R & L CARPENTER ADDITION

WICHITA, SEDGWICK COUNTY, KANSAS

Re: S/D 97-4 -- R. L. CARPENTER ADDITION (Final Plat)

STAFF REPORT
(Final Plat)

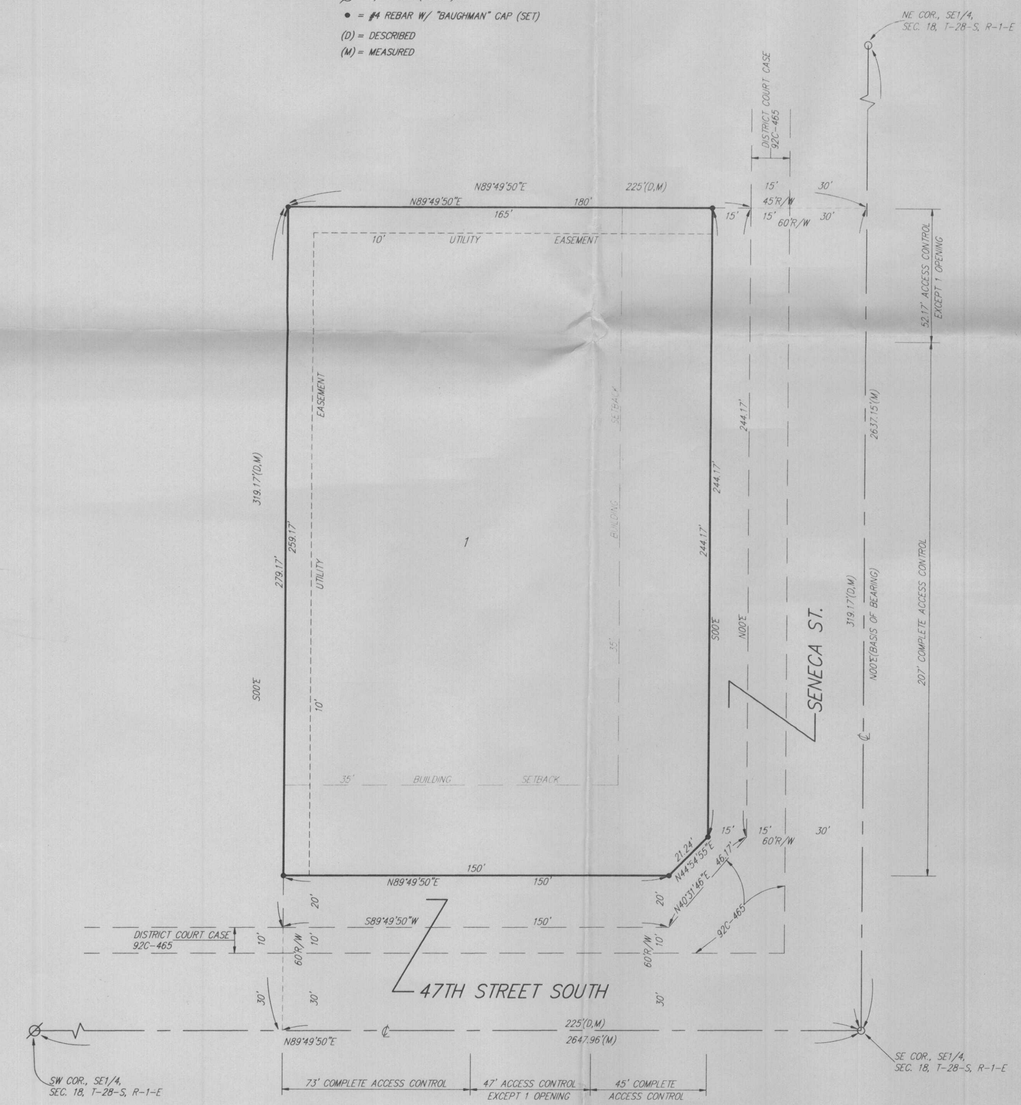
A. The applicant shall guarantee the extension of sanitary sewer to serve the lots being platted. Also, a 10-foot easement along the North line of this plat shall be granted for such sanitary sewer improvements.

C. As requested by the applicant, the final plat tracing may indicate 60 foot of half street right-of-way for 47th Street South and Seneca. As required by City Engineering, additional right-of-way at the plat's southeast corner will also be provided.

Complete access control will also be dedicated to 47th Street South across the East 45 feet and West 73 feet of this plat and across the South 207 feet of the site to Seneca. Outside of the areas of complete access control, one opening will be indicated to Seneca and one opening to 47th Street South. The dedication of this access control shall be referenced in the plattor's text in addition to being shown of the face of the final plat tracing.

C. Based on the sketch plat, it appears that there is an opening to 47th Street South in the area of complete access control. The applicant shall therefore guarantee the closure of any such opening.
